## THE ALTERED PLAN OF BRIDGEWATER HOUSE, LONDON.

We have been asked to give some information concerning the alterations which have been made in the internal arrangement of Bridgewater House, Cleveland-row, and cannot better comply with the request than by annexing a plan of the house as it is now proposed to be completed, which may be compared with the original plan given in our last volume (VI.), page 474.

## PRESENT PLAN OF BRIDGEWATER HOUSE.

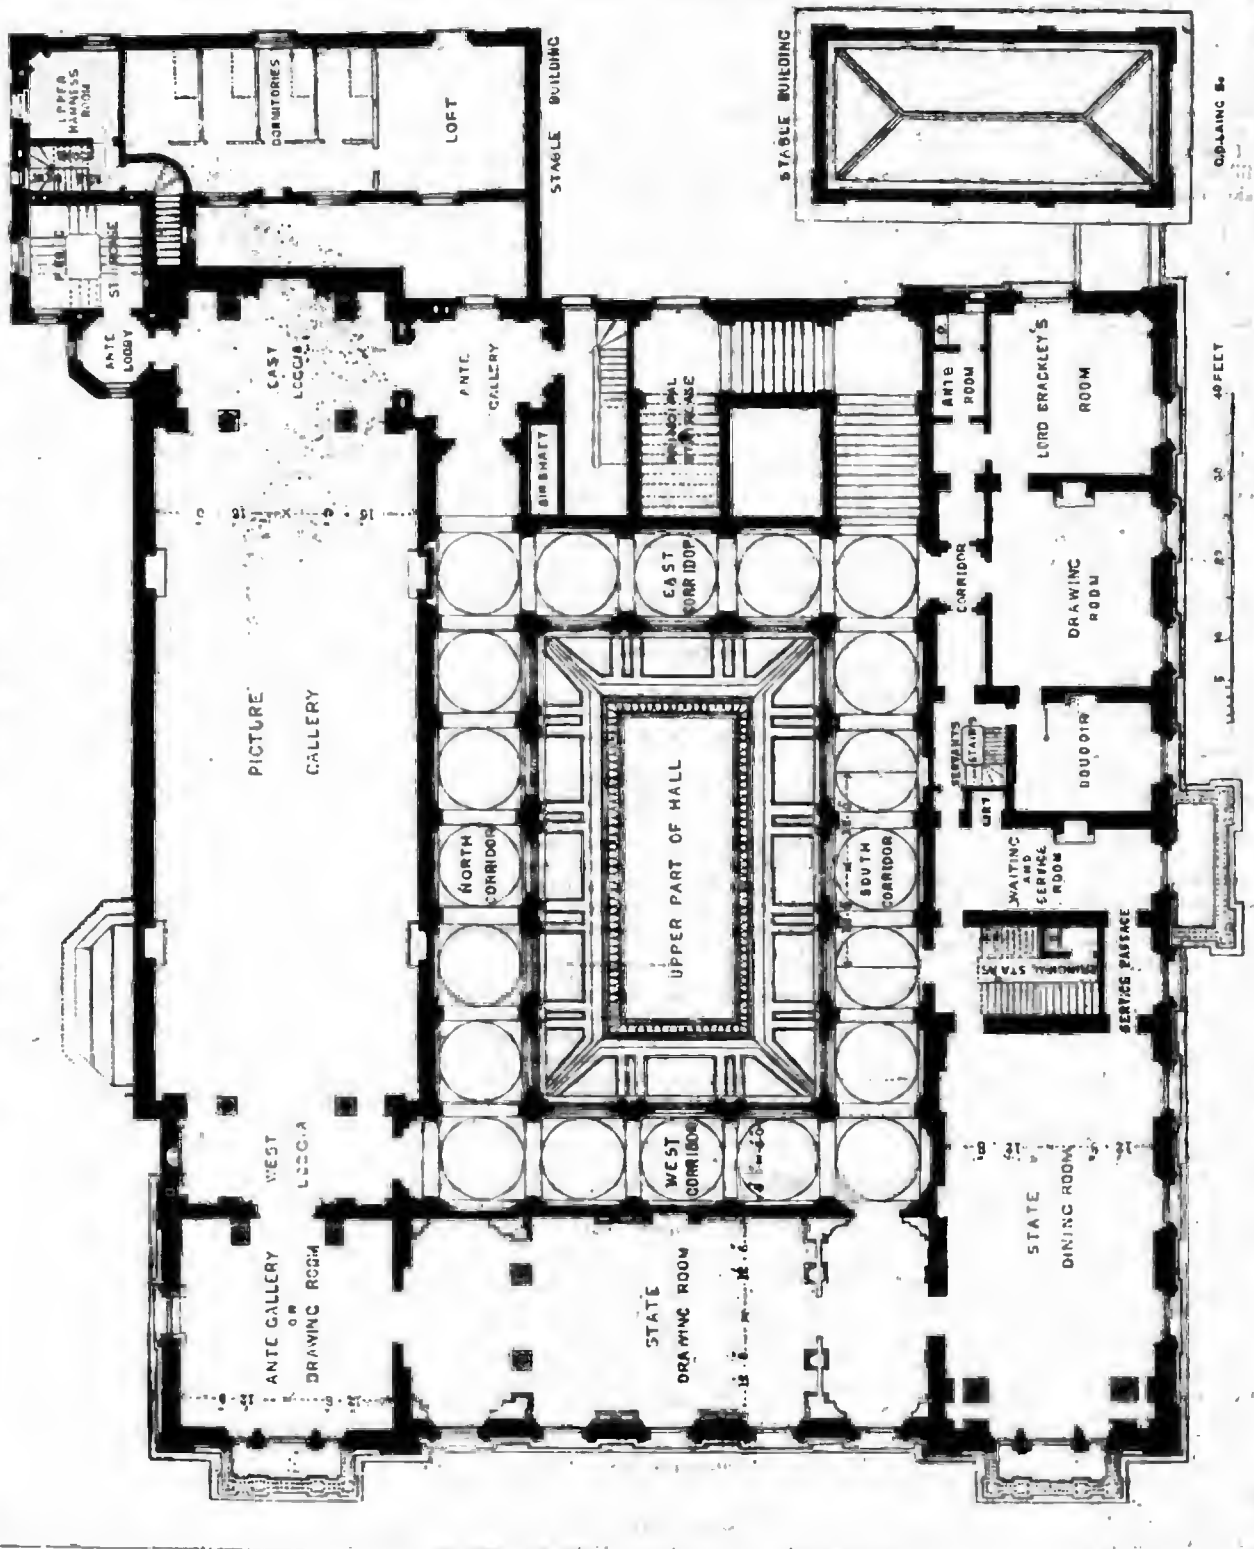
It will be seen that a central hall has been formed, and the principal staircase moved to the side. The chief motive of the alteration is understood to be a desire to render the gallery and its approaches independent of the rest of the building, it being Lord Ellesmere's intention to afford the greatest possible facilities to the public for visiting his fine collection. A separate staircase has been constructed, with this end in view, at the north-east corner, and is surmounted by a campanile.

The entrance to the central hall is under the

apartment marked "service-room" on the plan.

"With respect to the alteration to Bridgewater House, it might, in my opinion, have been better contrived. According to the first plan, there was no inner central hall on the ground-floor; now, on the contrary, there is too much,—one so disproportionably spacious and lofty, that, with the exception of the picture-gallery, all the rooms must look small by comparison with it,—that is, much smaller than they need do, or would have done, according to the first arrangement. Another

objection is, that, on its being first entered below, just as much will be seen as after ascending the staircase. Perhaps it would be better were the corridors to be partly enclosed, so as to leave only eight of the sixteen arcades open to the upper part of the hall, viz. three on each side and one at each end, which might be done not by stopping up those at the angles, but by merely glazing them with ornamental diapered or mosaic glass, in patterns of various colours; in which case the corresponding arcades below, if the corridors on the ground-floor be also quite open to the hall, ought to be closed up solid. That would confine the space sufficiently, and instead of the whole being disclosed at the first glance, parts would come into view successively,—would, after first appearing, disappear, and then appear again. It is not every architect that has a *forte* for *plan*—for so 'laying out' a mansion as to secure various effects by means of piquant contrasts, transitions, and combinations."
